AGENDA FOR REGULAR MEETING VILLAGE OF TINLEY PARK PLAN COMMISSION

Item #2 WORKSHOP: **JIMMY JOHNS - 7228 W. 191ST STREET, BLAKE PURNELL ON BEHALF OF C82 COMMERCIAL LLC, A SPECIAL USE PERMIT FOR A SUBSTANTIAL DEVIATION FROM THE BROOKSIDE MARKETPLACE PLANNED UNIT DEVELOPMENT**

PLAN COMMISSION STAFF REPORT

Project Number: 56518-IL01
Date: 11/16/2018
Subject: Staff Review-Response

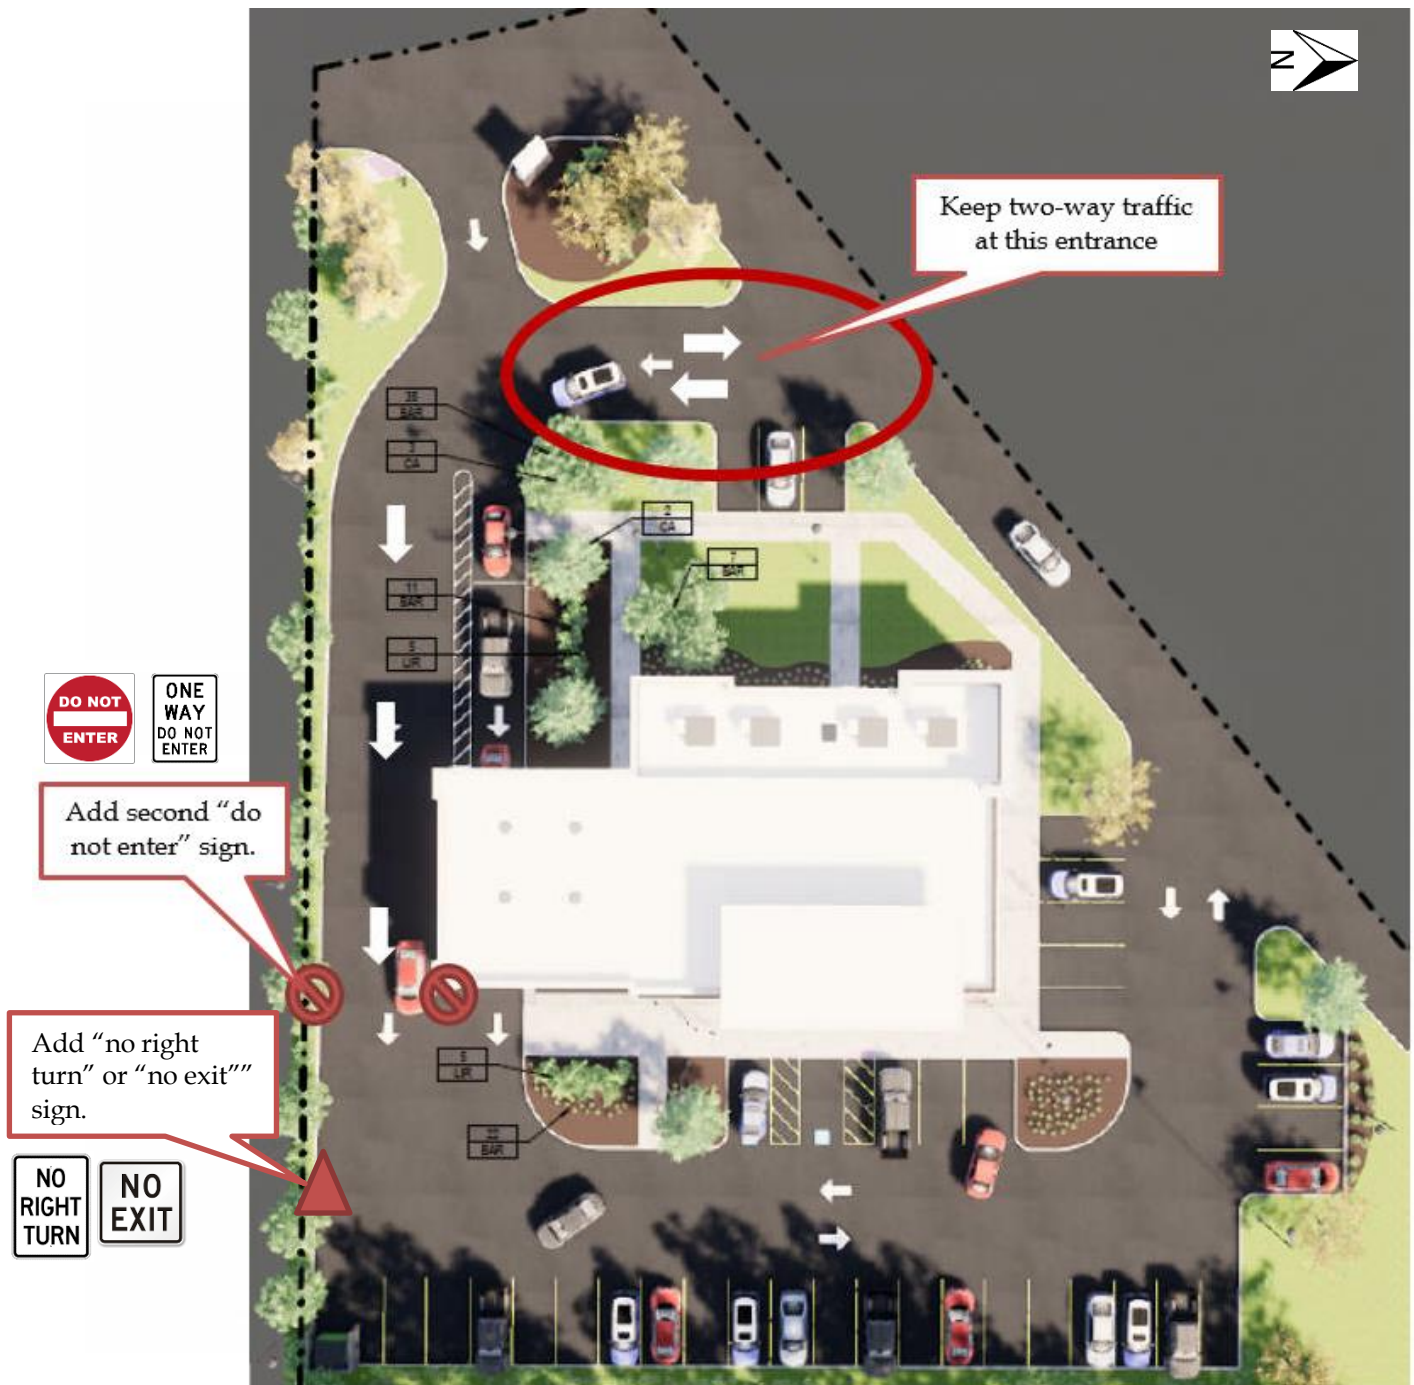
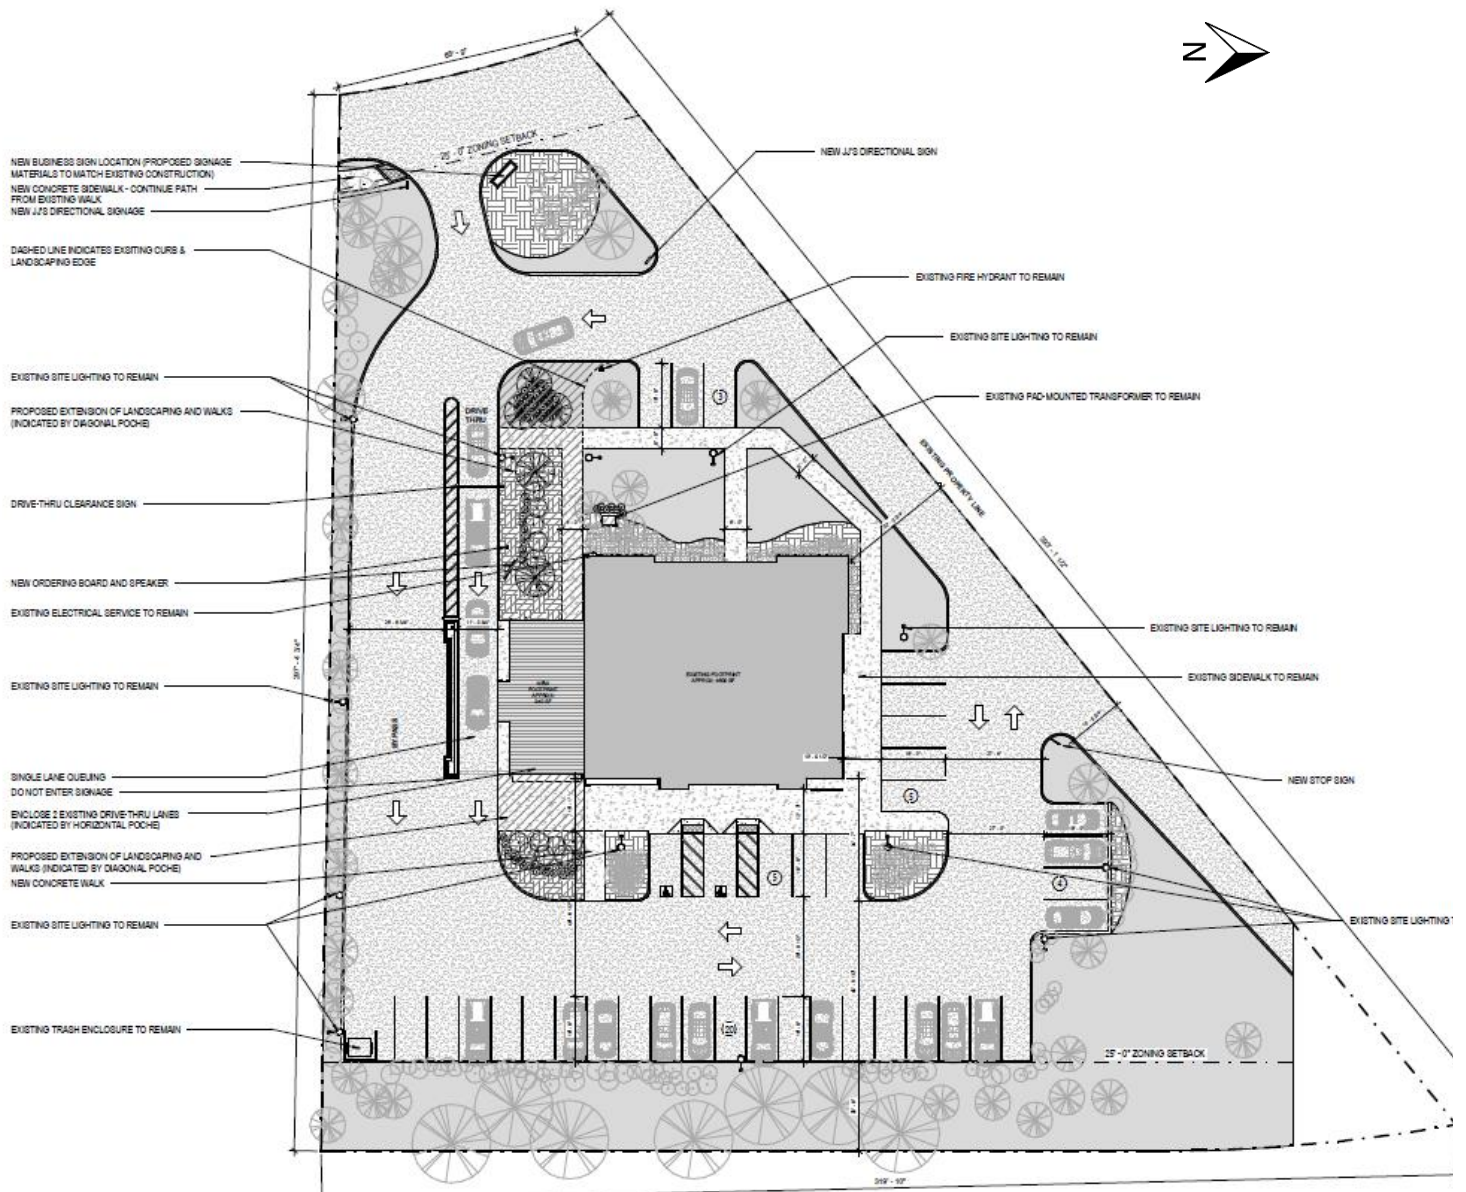
However, the width of the aisle is indicated at 26' 8.75" and is wide enough for two-way traffic. While it will be striped as one-way, it is still likely vehicles may go the wrong way down the aisle due to the extra width. A "do not enter" sign is proposed on the building by the exit to the drive-thru. A second "do not enter" sign should be placed

to the south of the drive aisle to further reinforce that traffic should not exit the site that direction. A “no right turn” or no exit sign should be placed at the end of the parking lane for warning as well. Additional consideration to reducing this drive-aisle width to between 15–18 feet should be considered. Dimensions of the entrances are not listed on the plans and will need to be indicated on the revised plans.

Open Item #3: Indicate drive-aisle dimensions on the site plan. One-way aisles should be between 15-18 feet in width and two-way drive aisles should be a minimum of 26 feet in width.

Open Item #5: Add a second “do not enter” sign on the south side of the one-way drive aisle due to the width. Add a “no right turn” or “no exit” sign at the end of the parking lot drive aisle. Consider reducing the width of the one-way drive aisle to between 15-18 feet to further avoid confusion.

LANDSCAPE NOTES

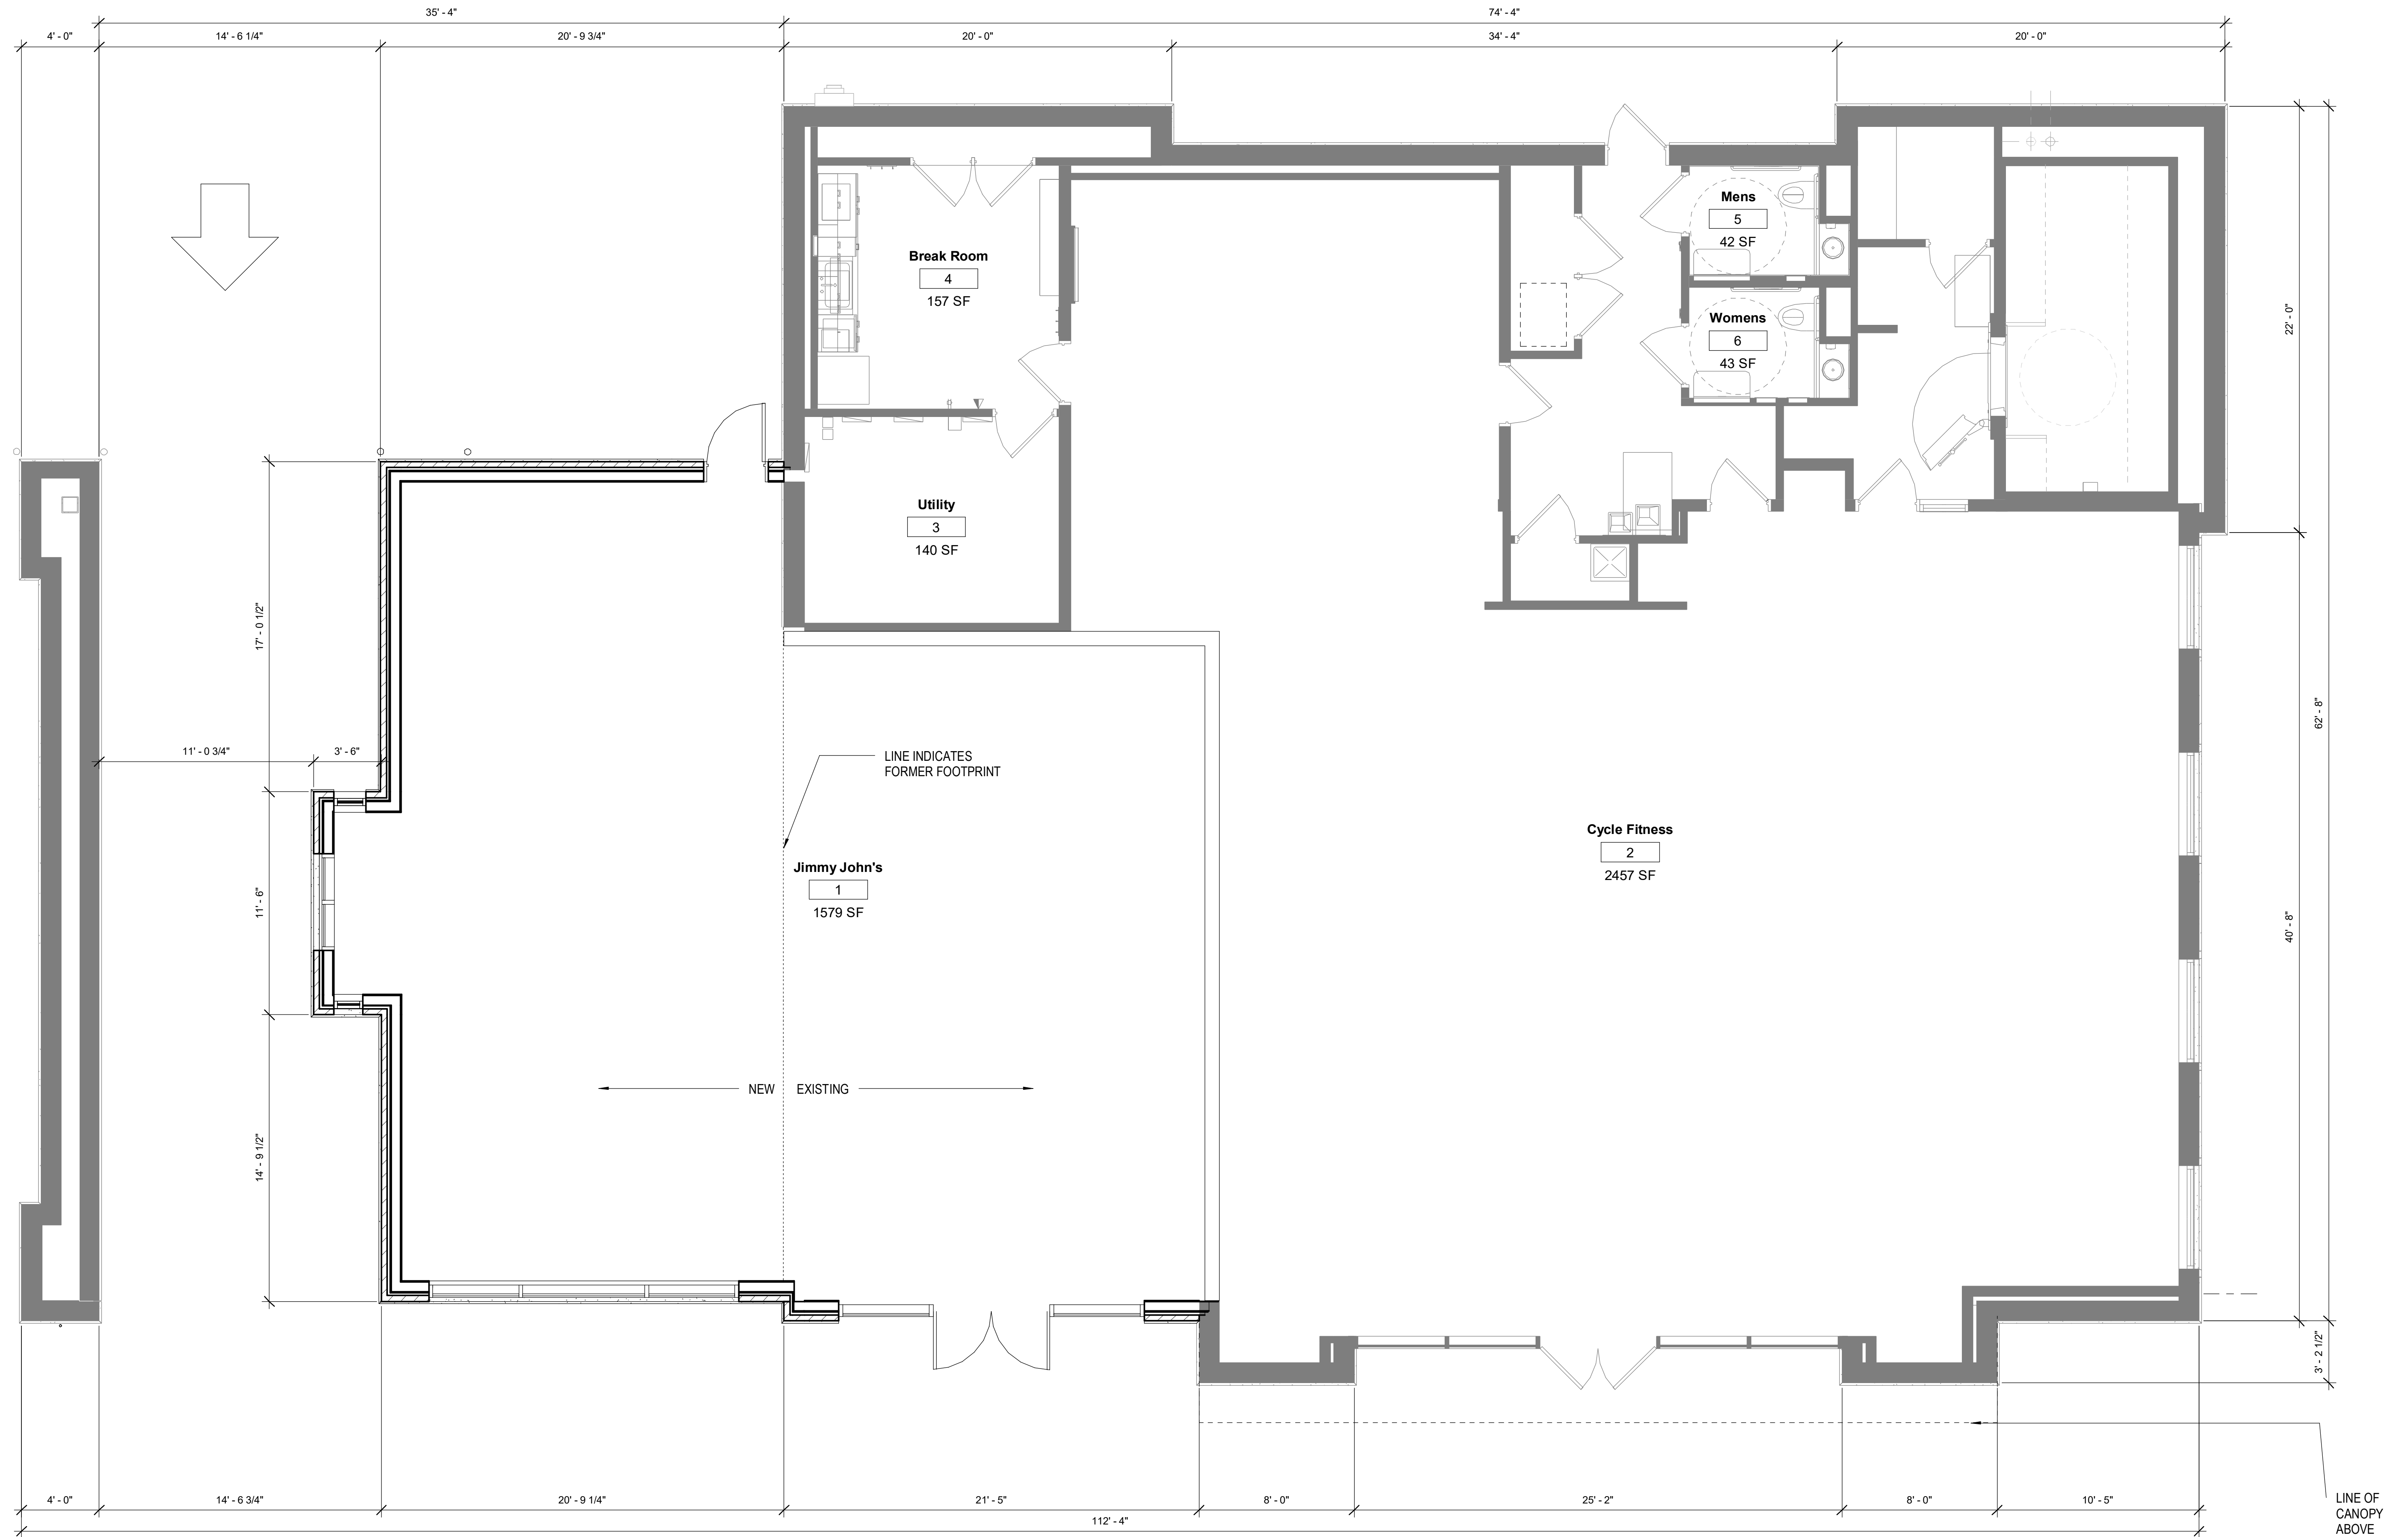
comments to the plan. Any new landscaping should indicate the number and species type on the landscape plan.

- [We added the Landscape plan to our submittal. Sheet contains required information including previously approved plantings, quantity existing and quantity new.](#)

1 East Elevation
1/4" = 1'-0"

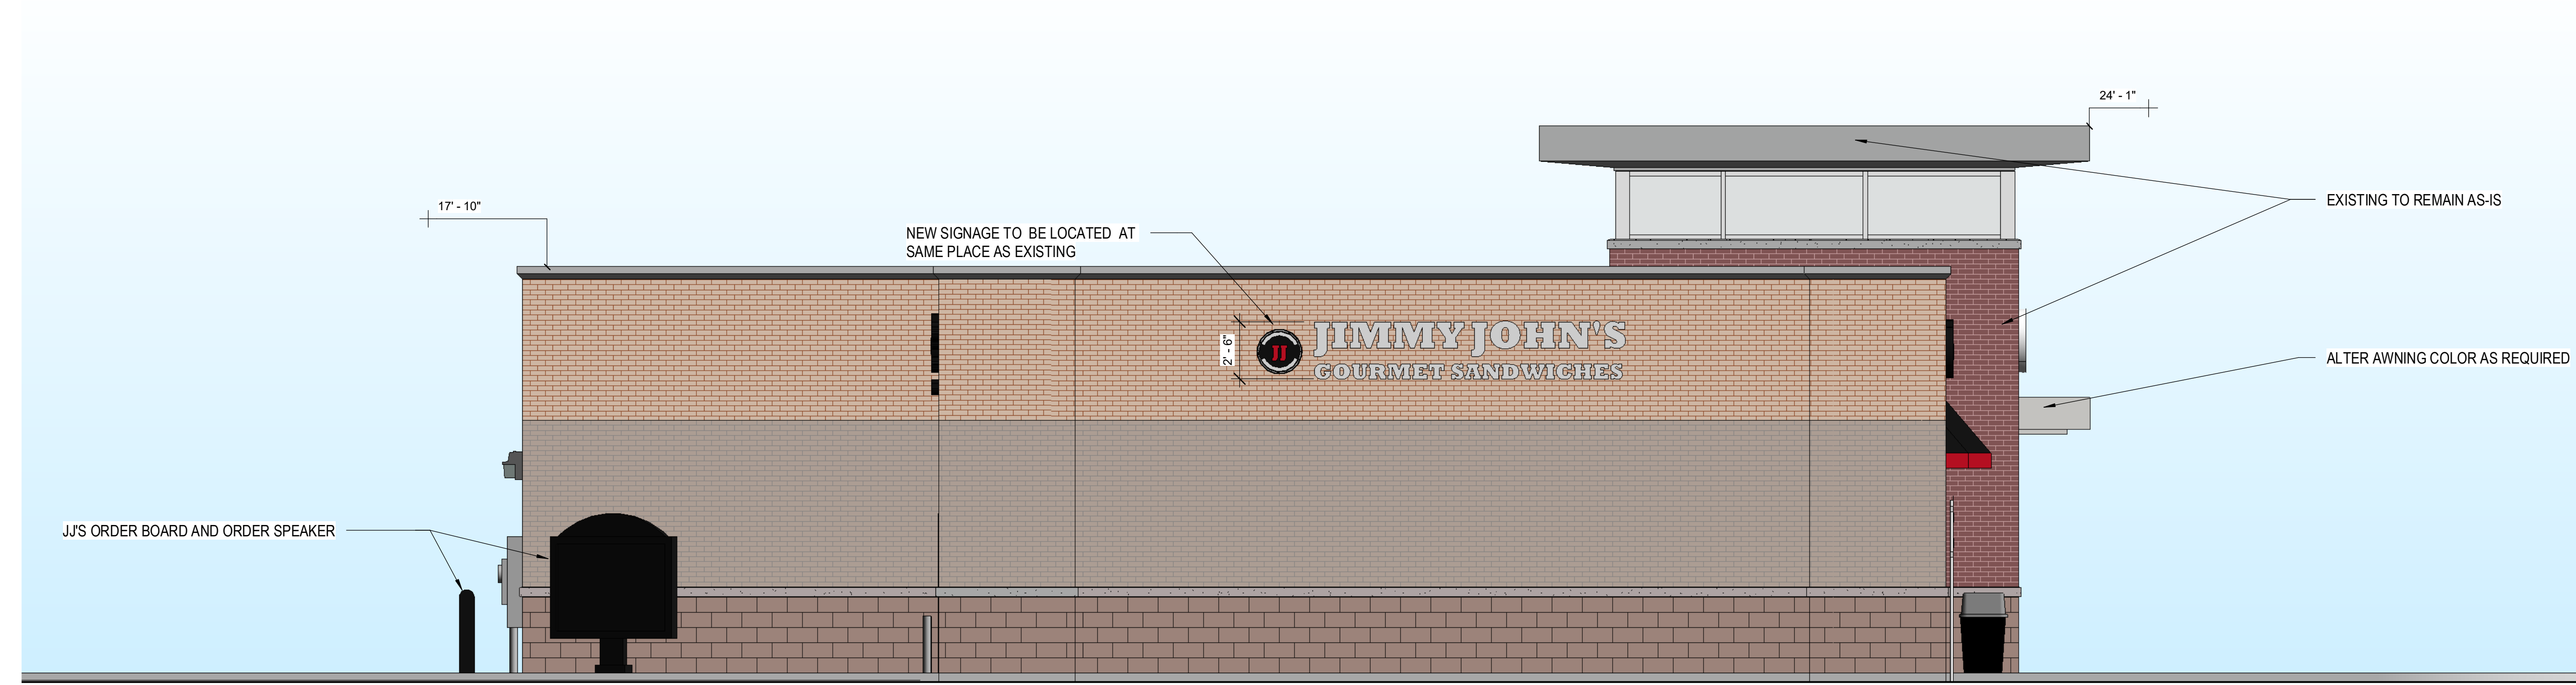
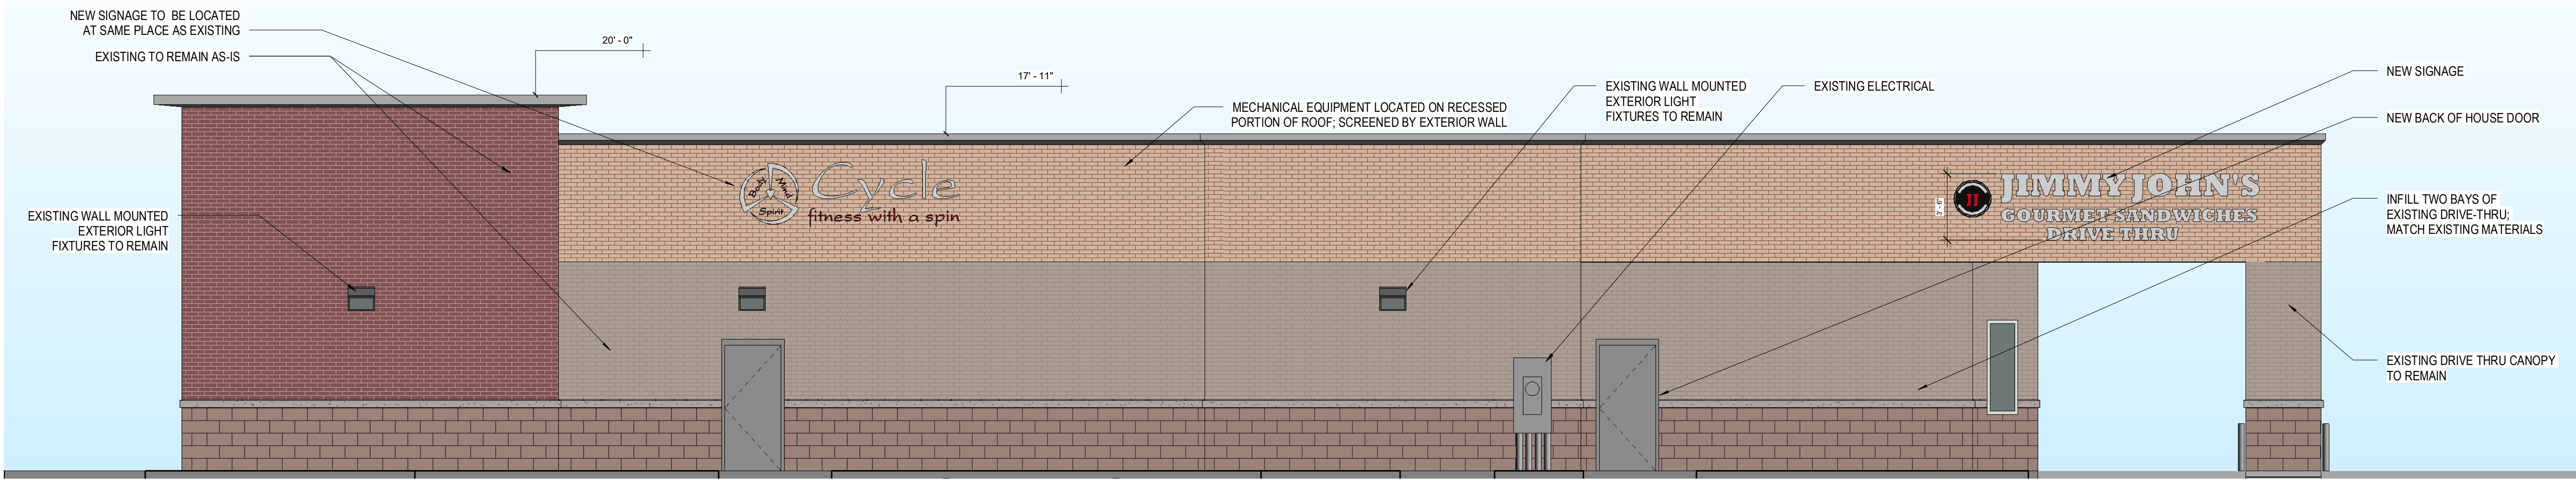
3. Exterior material percentages shall be listed on the plans. Per the PUD requirements, face brick or natural stone is required for a minimum of 60% of the exterior of the building, glass is permitted at a maximum of 30%, CMU/stucco/EIFS or other ornamental materials permitted at a maximum of 30%.

1. The exterior brick shall not be painted. The painting of brick causes regular maintenance concerns and cannot be undone as tenants change. No brick is painted throughout the rest of the shopping center and black is not a color utilized elsewhere on facades. The Jimmy John's space should be more consistent with current building's architecture and the existing shopping center designs. The proposed black and red awnings are acceptable though and will help to give the space the identity of a Jimmy John's.

- Proposed elevations list the materials and percentages. We are within the required amounts.
4. The originally proposed landscape plan is attached to this letter. Please complete a site analysis and make any adjustments based on the following

- [We revised as required. The new building finish materials are match the existing "approved" finish materials on exterior. Please see plan submittal.](#)
